PHASE III RI  
PLANT BUILDING INTERIOR  
WORK PLAN  
VAN DER HORST CORP. SITE  
PLANT NO. 1  
SITE NO. 9-05-008  
OLEAN, CATTARAUGUS COUNTY, NEW YORK

Re: Phase III RI Work Plan  
VanDerHorst Corporation Plant  
No. 1, Site No. 9-05-008

The NYSDEC's comments (3/20/91) on ERM's Phase III RI Work Plan (February 1991) to investigate the Plant 1 building interior have been reviewed. Our responses are provided below.

**Figure 3-1  
PROPOSED LOCATIONS FOR  
MONITORING WELLS AND SOIL BORINGS**

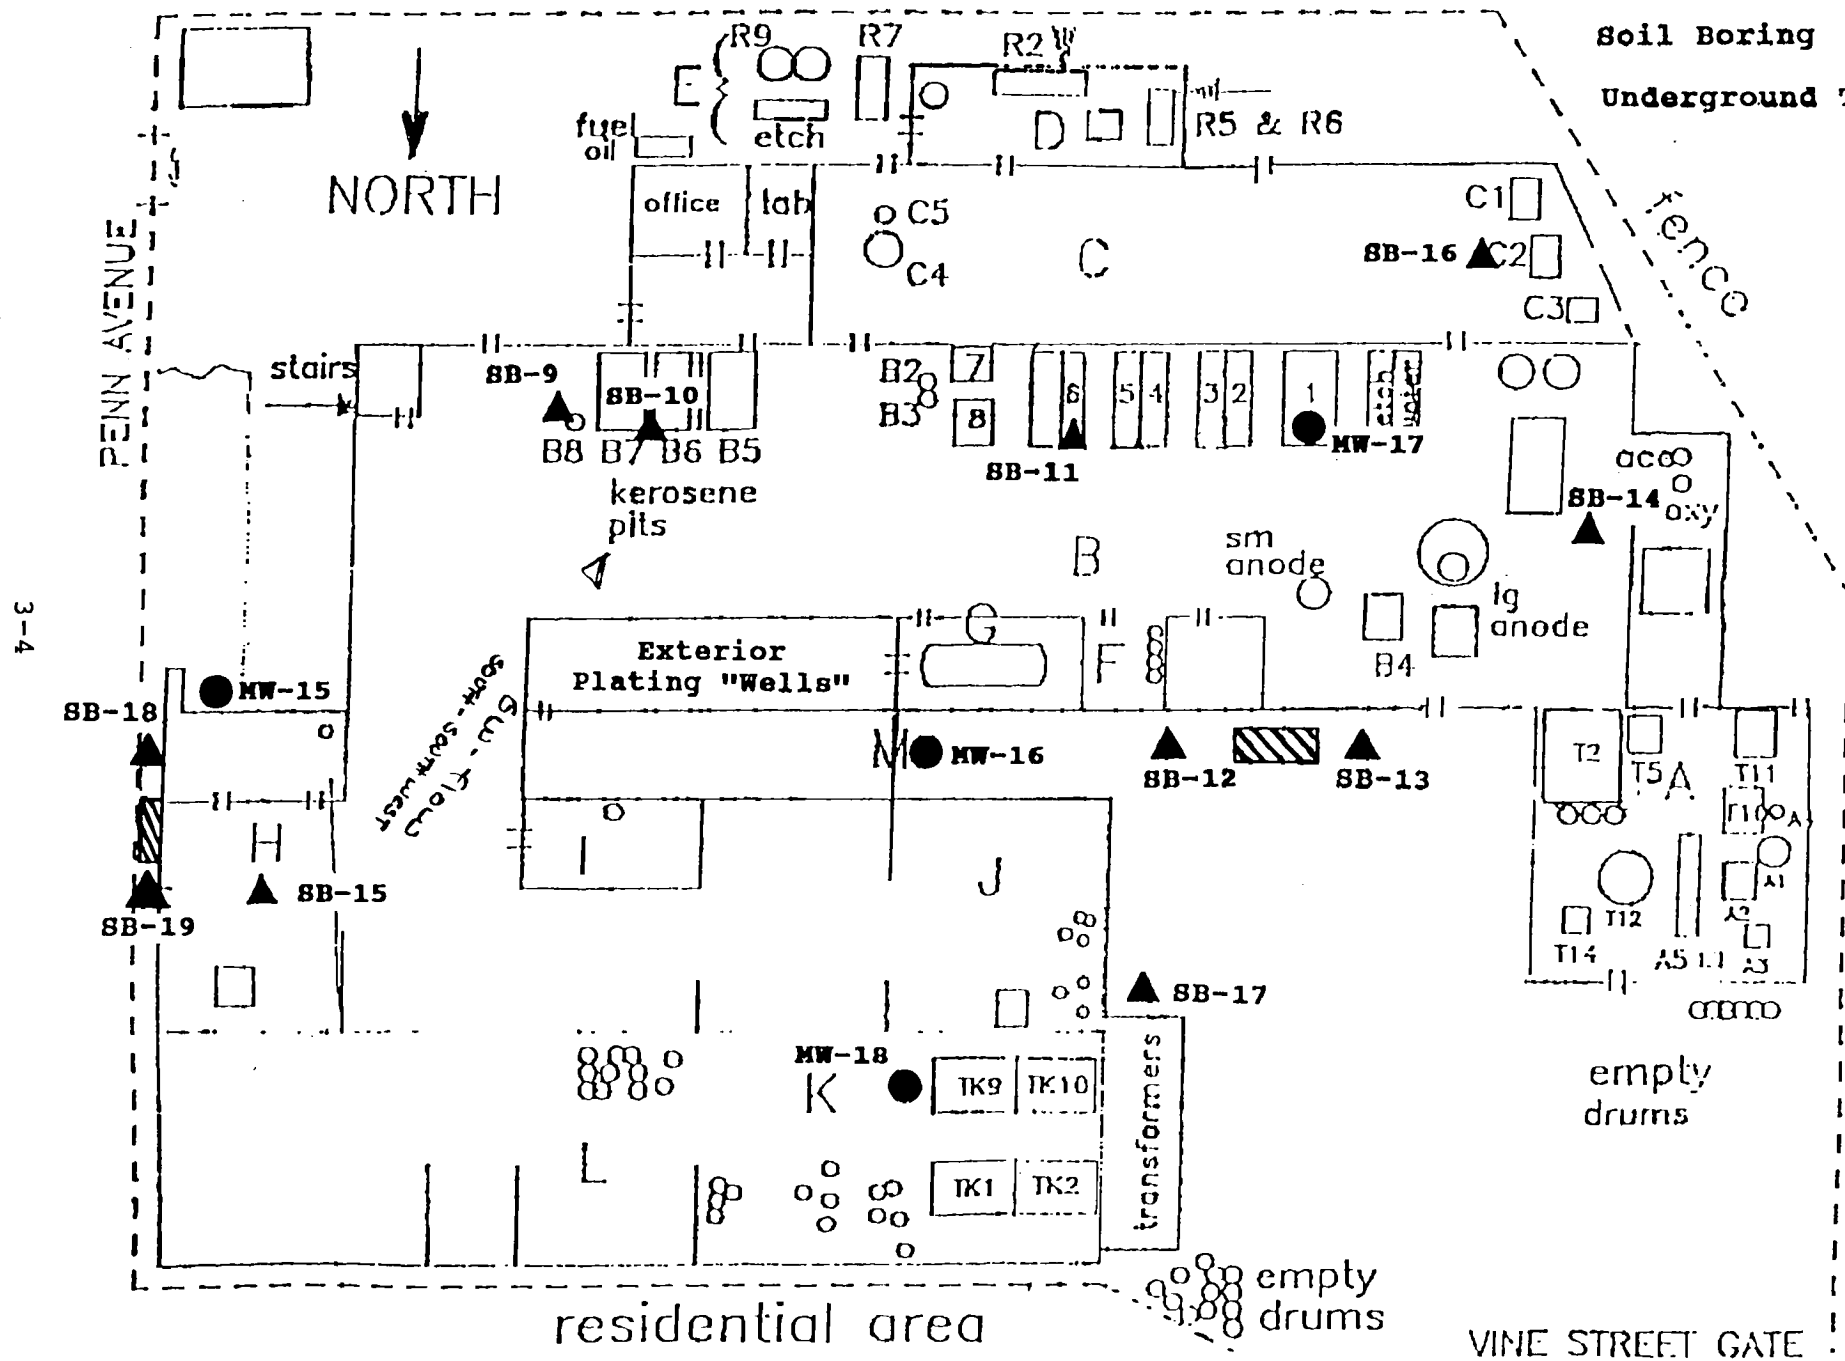
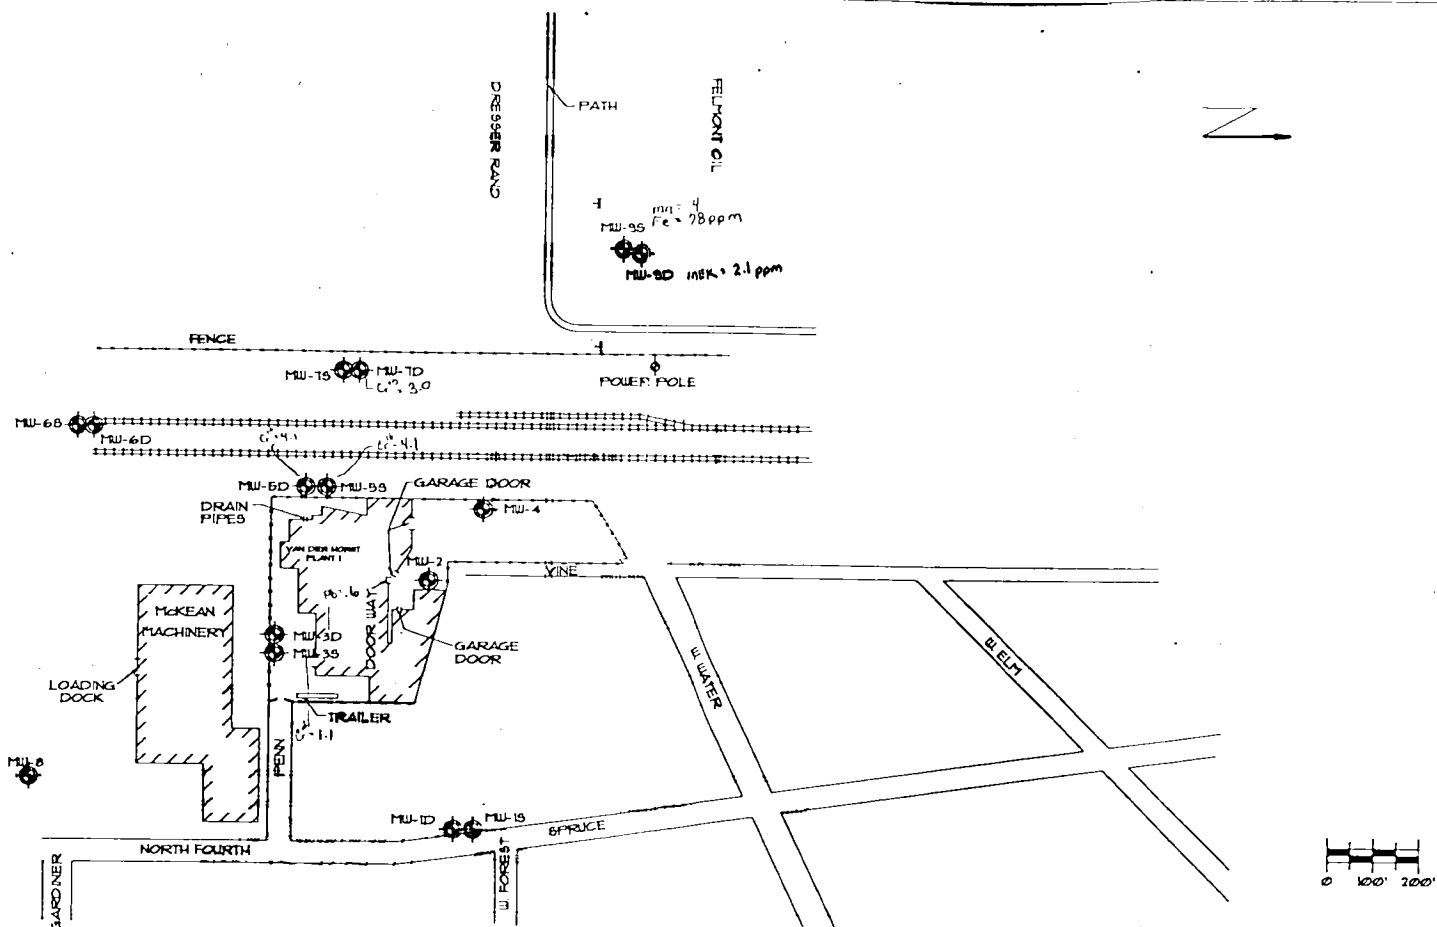
- 1) MW-15 - to assess whether suspected spills in the loading dock area have contributed to ground water and soil contamination. This location is also upgradient of the exterior plating "wells". *If G.W. flow is to S.W. as stated in phase I then this well will not be upgradient. suggest converted to boring*

- 2) MW-16 - to assess whether exterior plating "wells" in the courtyard area are a source of ground water contamination. *Semi upgradient to plating wells. mostly downgradient of MW-18 area.*

- 3) MW-17 - to assess whether potential leakage from the chromic acid plating tanks has resulted in ground water and soil contamination. *I would suggest well located next to tanks. not in them.*

- 4) MW-18 - to assess whether two tanks, one (1) chromic acid plating tank and one (1) caustic tank, are a source of ground water and soils contamination. Also, this area is where chlorinated solvents were stored. *Problem - this building has a low ceiling will be difficult to install a well - was this considered.*

- 5) ~~SB-13~~ - same as SB-12. *not needed*
- 6) SB-14 - to assess potential soil contamination levels adjacent to the "Lead Room".
- 7) SB-15 - to assess potential soil contamination in the degreasing area. *low ceiling area - don't believe boring possible if performed deep (20ft).*

- 10) SB-18 - to assess potential contamination adjacent to the underground storage tank on the east side of the plant building.
- 11) ~~SB-19~~ - same as SB-18. *not needed*

COMMENT 6: Agreed, but we would like to install boring SB-9 in the former location of MW-15. During our site walkthrough with Mr. Gino Lorenzino, it was mentioned that spillage had occurred off of the loading dock. Concerning MW-18, Buffalo Drilling has seen all of the proposed boring locations and believes that all are accessible. They plan to use a skid rig for the interior drilling.

With regards to the two sets of borings SB-12/13 and SB-18/19, we would like to perform two borings outside of each tank because we are not sure how close we can get to the tanks, and no tank installation records are available to help locate their boundaries. Also, background interference will prevent us from attempting to delineate the tank using a magnetometer survey.
